TECHNICAL SERVICE BULLETIN

Horn Sounds When Turning The Steering Wheel

26-2280
10 June 2026

Ford 2025-2026 Expedition

Figure 1

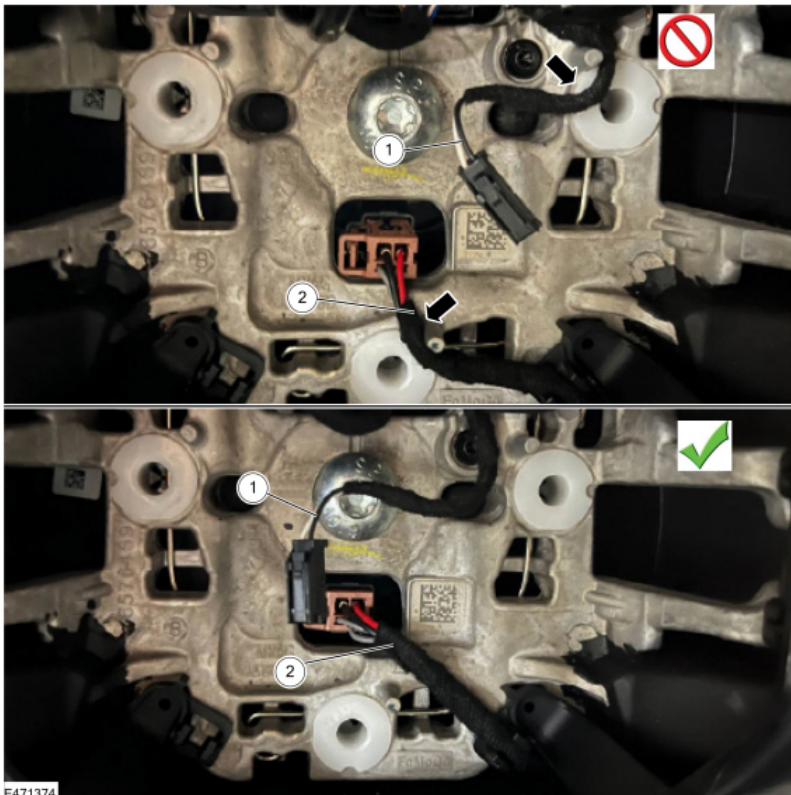
1. Remove the driver airbag. Refer to the [WSM](#), Section 501-20B Supplemental Restraint System > Removal and Installation > Driver Airbag.
2. Carefully inspect for impressions on the horn wire harness (Figure 1, Callout 1) and heated steering wheel (if equipped) wire harness (Figure 1 Callout 2) that would indicate the harness was pinched under one of the airbag mounting springs. Repair the harness if damaged. Refer to Wiring Diagram, Cell 005.
 - (1). Make sure that the horn wire harness is routed to the left of the cast aluminum locator pin, and the heated steering wheel harness (if equipped) is routed to the right of the cast aluminum locator pin to keep the harnesses away from the airbag springs. Correct the harness routing as needed (Figure 1).

Figure 3

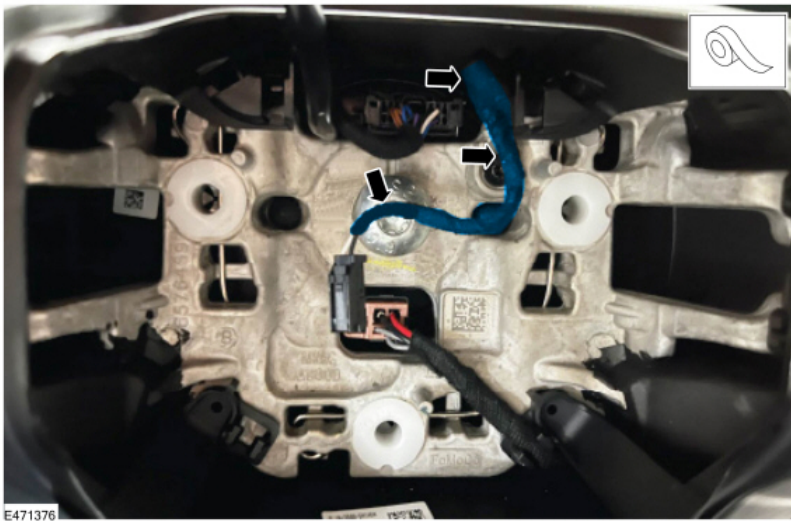
4. Thoroughly wrap the horn wire harness branch lead (that attaches to connector C217 on the driver airbag) with an additional layer of Coroplast® wire harness tape from the connector end back to the main steering wheel harness. (Figure 3)

Figure 5

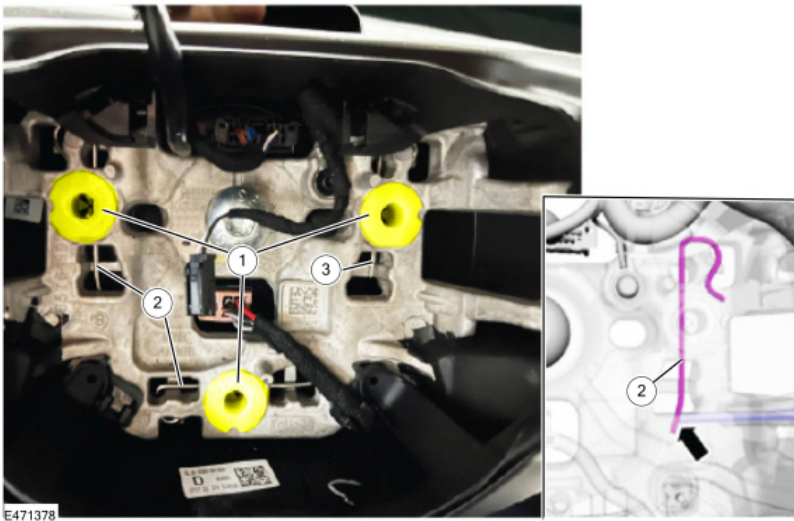
6. Inspect the 3 plastic guide bushings for any damage. Confirm the 3 spring clips are present, undamaged, and fully seated. Repair as necessary outside of this article. (Figure 5)
